TURKEY POINT PLANT UNIT NO. 3

AMENDMENT TO FACILITY OPERATING LICENSE

Amendment No. 144  
License No. DPR-31

ATTACHMENT TO LICENSE AMENDMENT

Figure 3.1.2.5

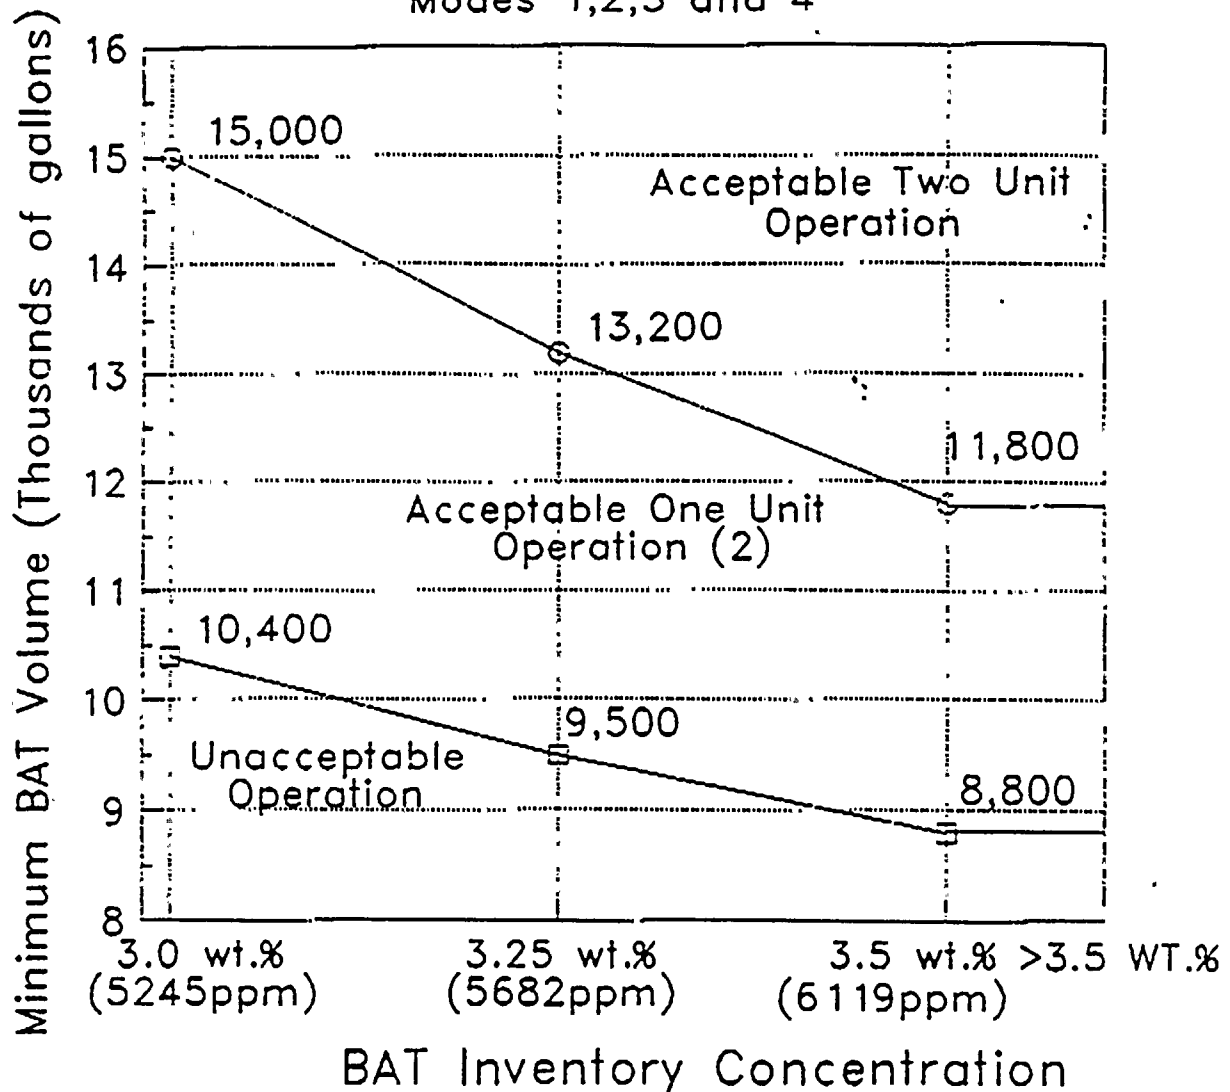
- 1) A minimum indicated borated water volume in accordance with Figure 3.1.2.5,
- 2) A boron concentration in accordance with Figure 3.1.2.5, and
- 3) A minimum boric acid tanks room temperature of 55°F.

(1) Combined volume of all available boric acid tanks assuming RWST boron concentration greater than or equal to 1950 ppm.

(2) Includes 2900 gallons for shutdown unit.
